Technical Service Bulletin: TSB260089

Vibration Damper Guard

- QST30 CM552

Figure 1, Capscrew Assembly for Top Mounting Locations

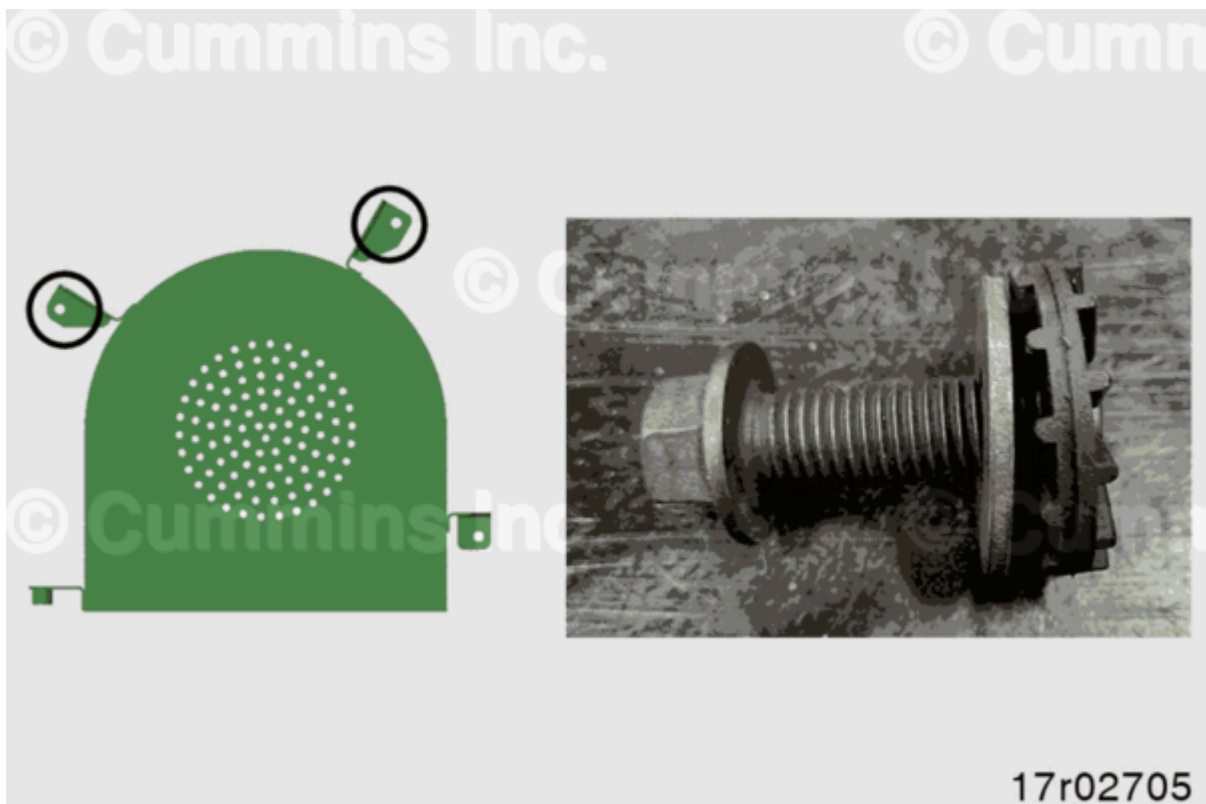
The top mounting locations will each use:

- Part Number 3920447 – capscrew – quantity 1
- Part Number 4975786 – retaining ring – quantity 1 (**Not** visible in picture, locate between bracket and first washer)
- Part Number 3041247 – plain washer – quantity 1
- Part Number 3035083 – isolator – quantity 1

Figure 2, Capscrew Assembly for Bottom Right Mounting Location

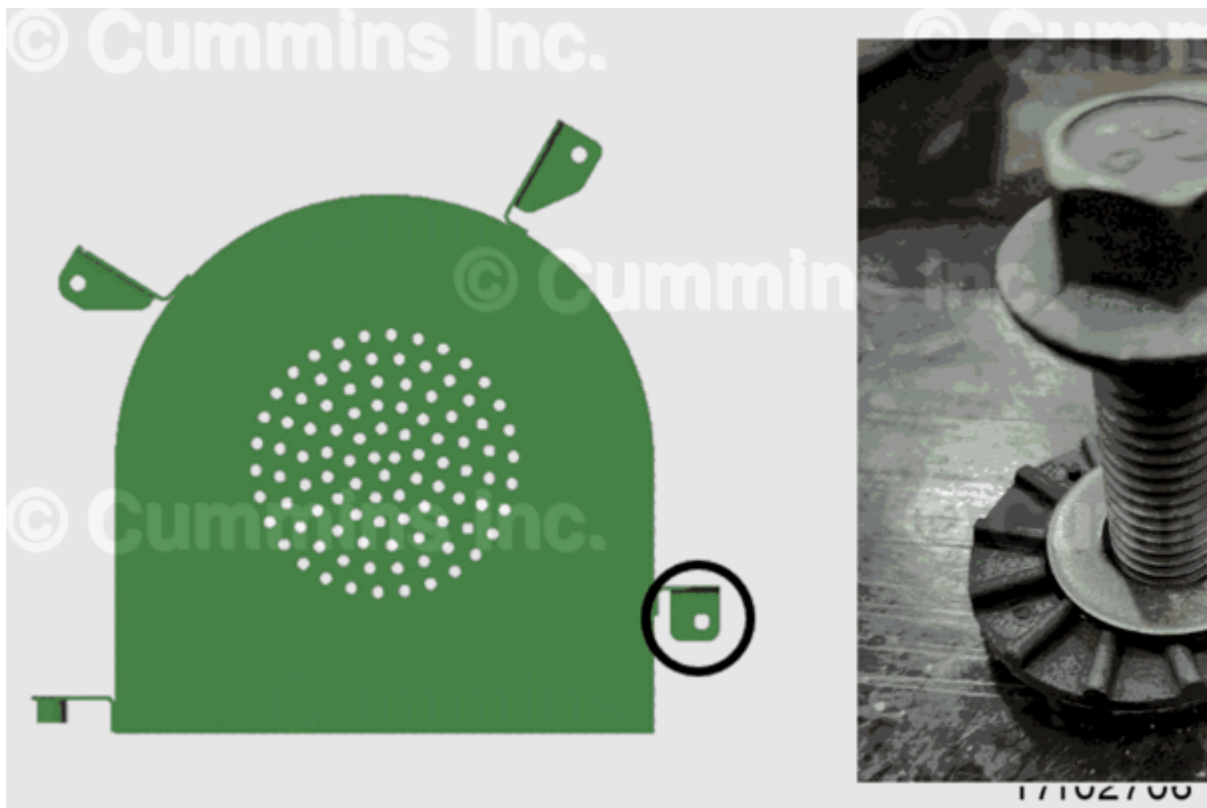
The bottom right mounting location will use:

- Part Number 3920447 – capscrew – quantity 1
- Part Number 4975786 – retaining ring – quantity 1 (**Not** visible in picture, locate between bracket and first washer)
- Part Number 3035806 – plain washer – quantity 1
- Part Number 3035083 – isolator – quantity 1

Figure 3, Capscrew Assembly for Bottom Left Mounting Location

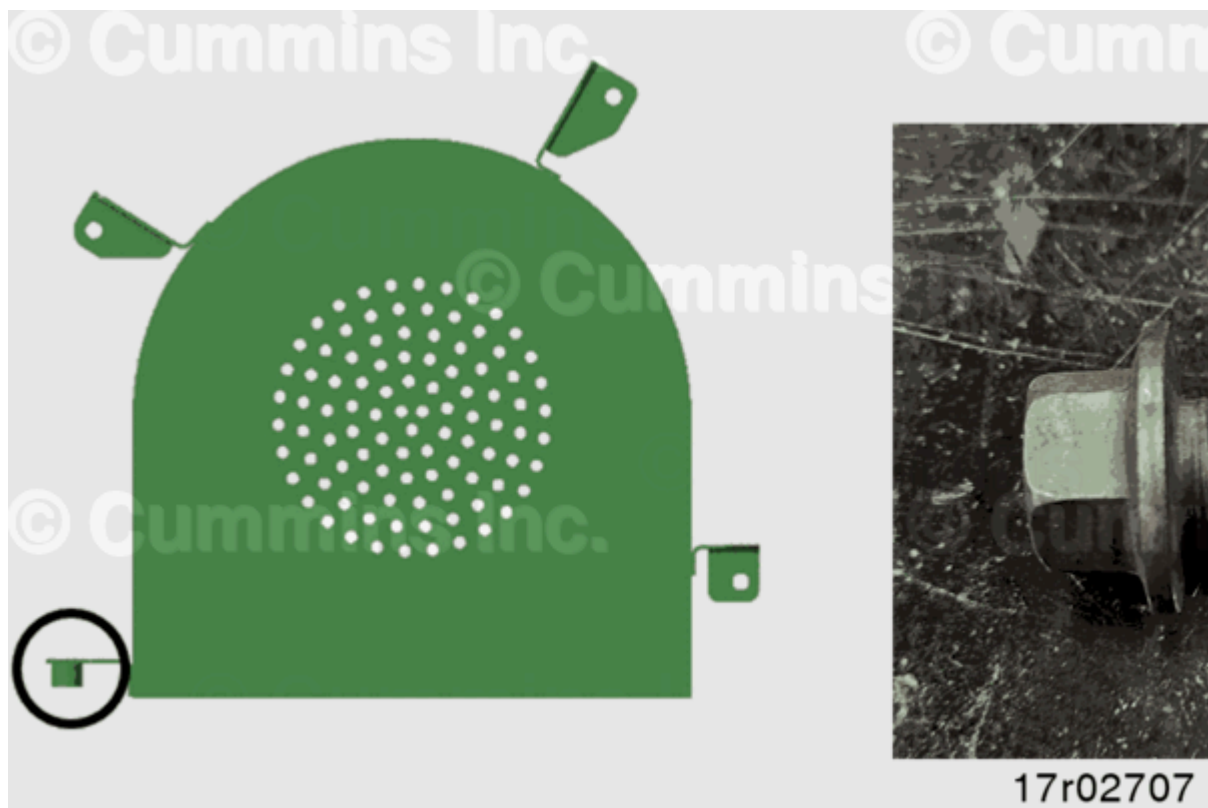
The bottom left mounting location will use:

- Part Number 3920447 – capscrew – quantity 1
- Part Number 4975786 – retaining ring – quantity 1 (**Not** visible in picture, locate between bracket and isolator)
- Part Number 3035083 – isolator – quantity 1

Figure 5, Top Right Mounting Location after Install

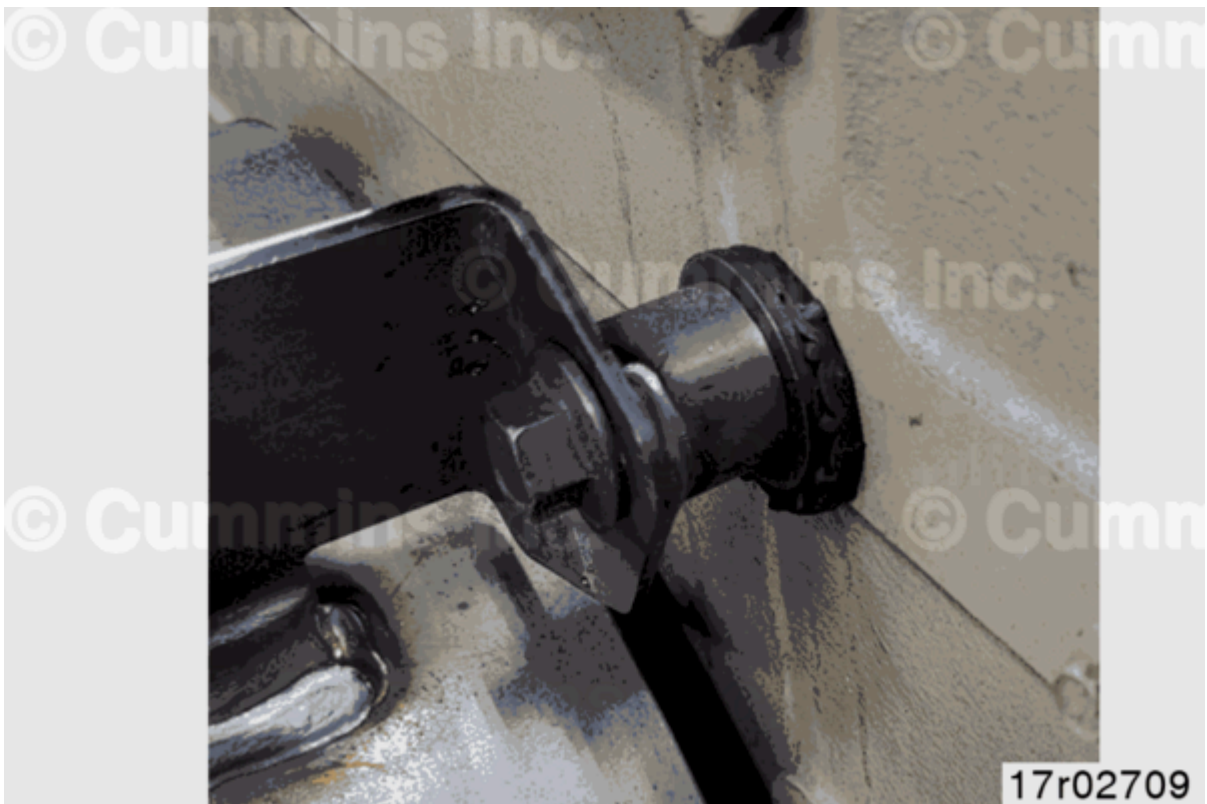
2. Apply Loctite® to capscrew threads.
3. Position the vibration damper guard onto the engine and hand start the capscrews in the top mounting locations.
4. Hand start the capscrew in the bottom right location. The washer and isolator will be off center for clearance to the cover plate.
5. Hand start the capscrew in the bottom left location through the vibration damper guard and breather tube bracket.
6. Tighten capscrew assemblies until the isolator thickness is 2 mm [0.079 in] nominal.
